ALERT SERVICE BULLETIN

206L-23-188

Revision A, 27 March 2024

SUBJECT: HORIZONTAL STABILIZER AND CARGO HOOK FITTINGS – SELF LOCKING INSERTS, INSPECTION OF

Figure 1 (Sheet 1 of 2) – Horizontal Stabilizer Inspection

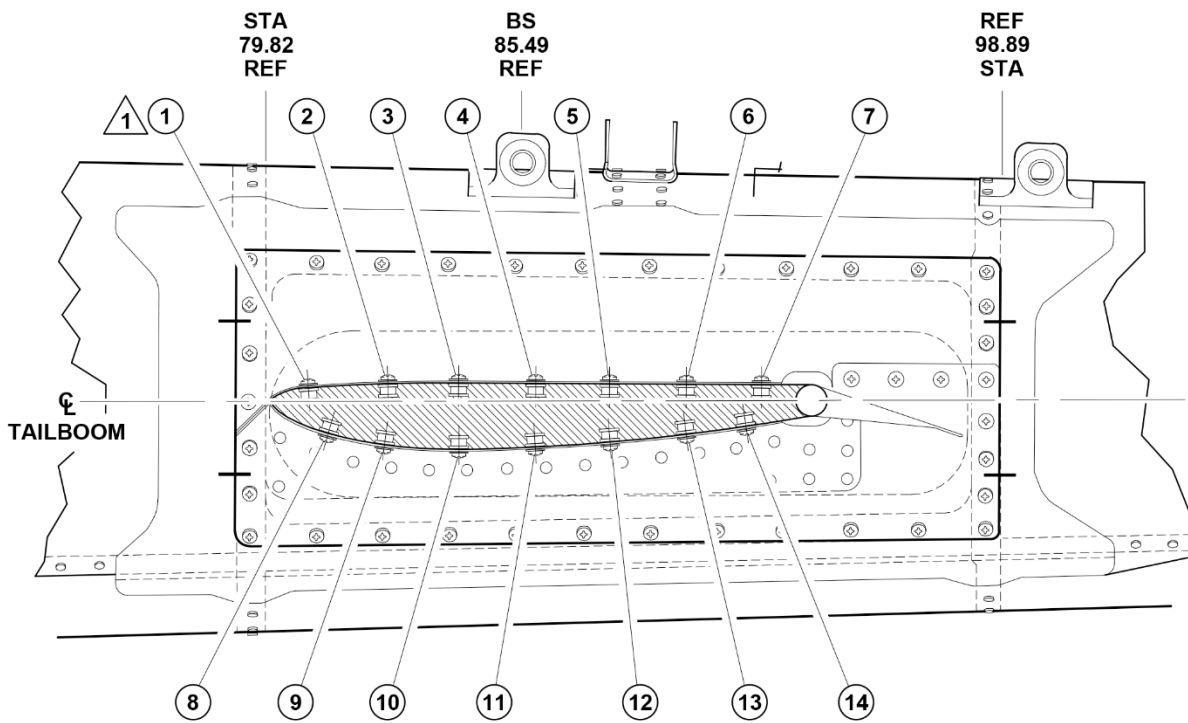
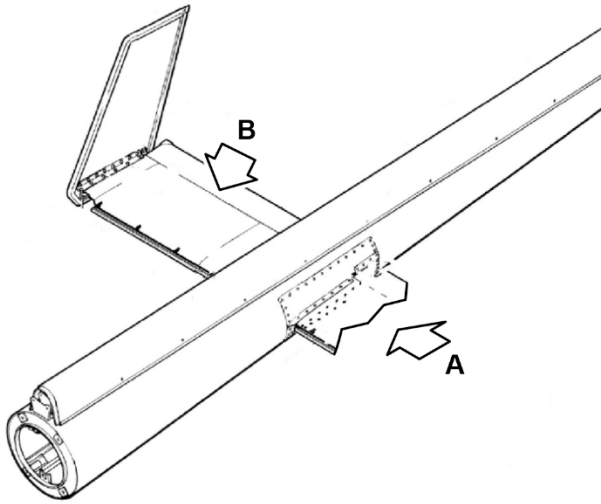
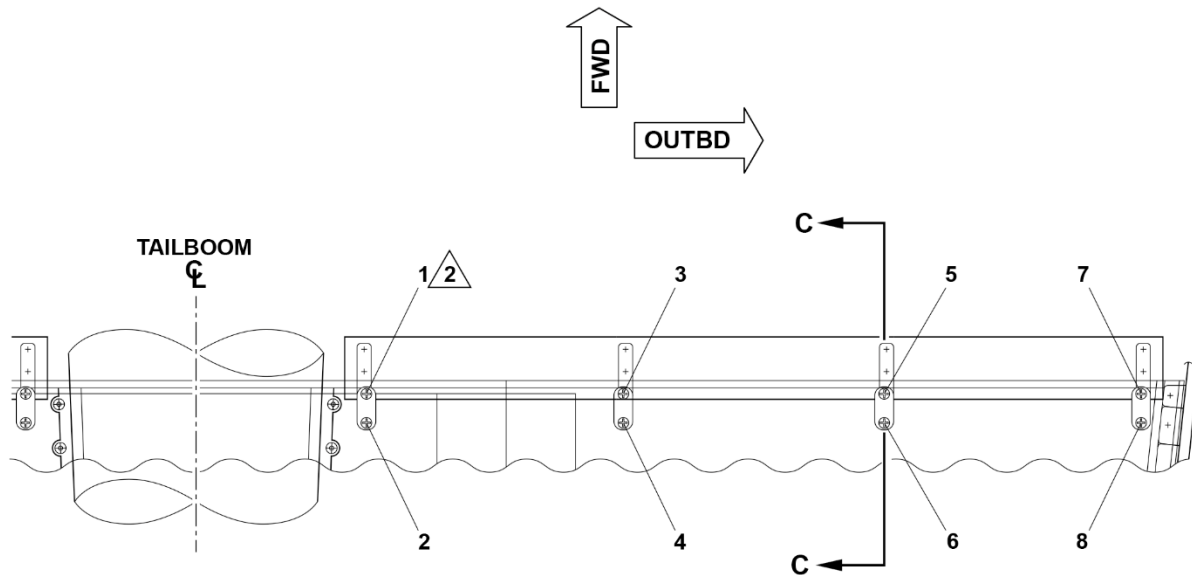
6. Perform a visual inspection of the following horizontal stabilizer fasteners for signs of looseness:
 - a. Fasteners (Qty 28) attaching the horizontal stabilizer to the support (Figure 1, Sheet 1).

8. If any sign of fastener loosening is detected at the horizontal stabilizer to support attachment, perform the following for every suspected insert:
 - a. Remove the fastener and measure the tare torque of the insert (BHT-ALL-SPM Chapter 2, Section 2). The minimum tare torque of the inserts shall be 2.0 inch-pounds (0.23 Nm).

- b. If the tare torque of the insert meets the minimum value, re-install the fastener (ASB 206L-99-115, Part III, Step 38).
 - c. If the tare torque of a specific insert is below the minimum value, do the following:

- (1) Replace the existing fastener with a new one (ASB 206L-99-115, Part III, Step 38).
 - (2) Measure the tare torque as per step 8.a.
 - (3) If the tare torque is sufficient, install the new fastener (ASB 206L-99-115, Part III, Step 38).

- (4) If the tare torque of the horizontal stabilizer to support is not sufficient, apply a drop of low strength threadlocker Loctite 080 (C-320) on the threads of the new fastener and a layer of sealant (C-251) on the shank of the screw (ASB 206L-99-115, Part III, Step 38). Install the fastener and apply a stripe of torque seal lacquer (C-049) on the affected fastener.

Figure 1 (Sheet 2 of 2) – Horizontal Stabilizer Inspection

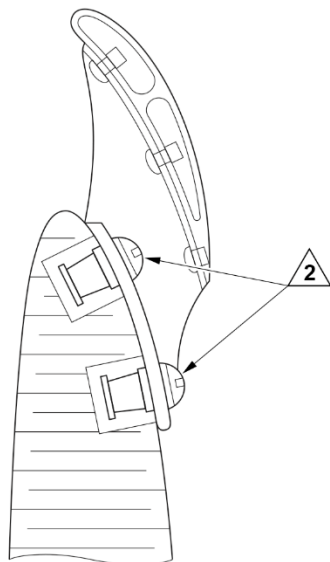
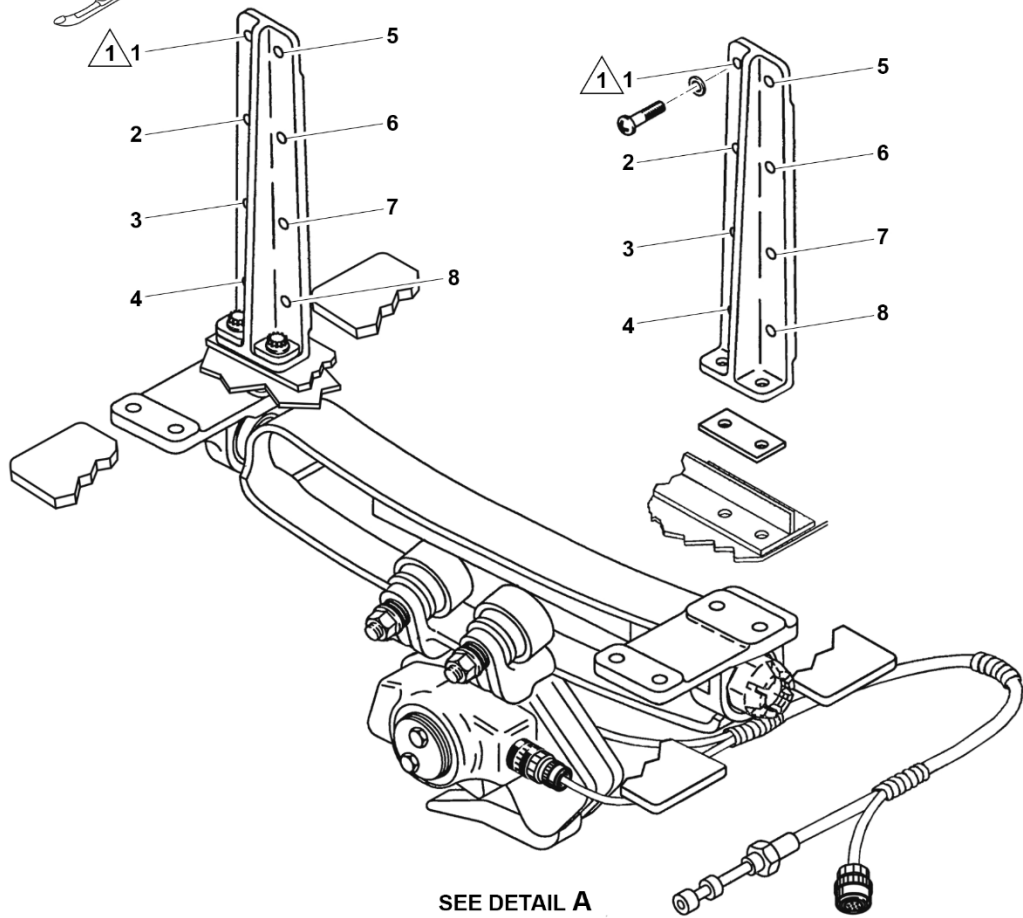
- b. Fasteners (Qty 16) attaching the slats to the horizontal stabilizer (Figure 1, Sheet 2).
7. If there are no signs of fastener loosening, proceed to step 11.

9. If any sign of fastener loosening is detected at the slats to horizontal stabilizer attachment, perform the following for every suspected insert:
 - a. Remove the fastener and measure the tare torque of the insert (BHT-ALL-SPM Chapter 2, Section 2). The minimum tare torque of the inserts shall be 2.0 inch-pounds (0.23 Nm).

- b. If the tare torque of the insert meets the minimum value, re-install the fastener (BHT-206L-MM, Chapter 53).
 - c. If the tare torque of a specific insert is below the minimum value, do the following:

- (1) Replace the existing fastener with a new MS27039-1-06 screw.
 - (2) Measure the tare torque as per step 9.a.
 - (3) If the tare torque is sufficient, install the new fastener. (BHT-206L4-MM, Chapter 53)

- (4) If the tare torque of the fasteners attaching the slats to the horizontal stabilizer is not sufficient, apply a drop of low strength threadlocker Loctite 080 (C-320) on the threads of the new fastener. Install the fastener and apply a stripe of torque seal lacquer (C-049) on the affected fastener (BHT-206L4-MM, Chapter 53).

Figure 2 – Cargo Hook Fittings Inspection

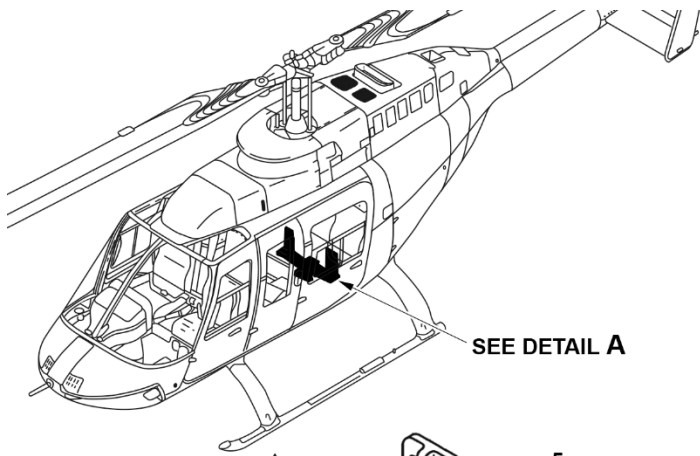
5. Verify the tare torque on the attaching fasteners (Qty 16) of the cargo hook fittings on the passenger seat bulkhead (Figure 2) as follow. Verify one fastener at a time. (BHT-206-SI-2012)
 - a. Measure the tare torque of the insert (BHT-ALL-SPM Chapter 2, Section 2).
 - b. The minimum tare torque of the inserts shall be 2.0 inch-pounds. (0.23 Nm).
6. If the tare torque of a specific insert does not meet the minimum value, do the following for each discrepant insert:
 - a. Remove and discard the screw installed in the discrepant insert. Retain washer if it is serviceable.
 - b. Remove and discard a screw installed in a vertically adjacent insert. Retain washer if it is serviceable.

- c. Install new bolts NAS6603H4 with one washer NAS1149D0332J at the locations where the original screws were discarded.
 - d. Torque the bolts to 20-25 inch-pounds (2.3-2.8 Nm) plus tare torque.
 - e. Safety the new bolts together using (C-405) safety wire (BHT-ALL-SPM, Chapter 8).
 - f. Torque all other disturbed fasteners to 20-25 inch-pounds. (2.3-2.8 Nm) plus tare torque.
7. If inserts with tare torque below the minimum requirement are found, report the results to Product Support Engineering at productsupport@bellflight.com.
8. Make an entry in the helicopter logbook and historical service records indicating compliance with **PART II** of this Alert Service Bulletin.
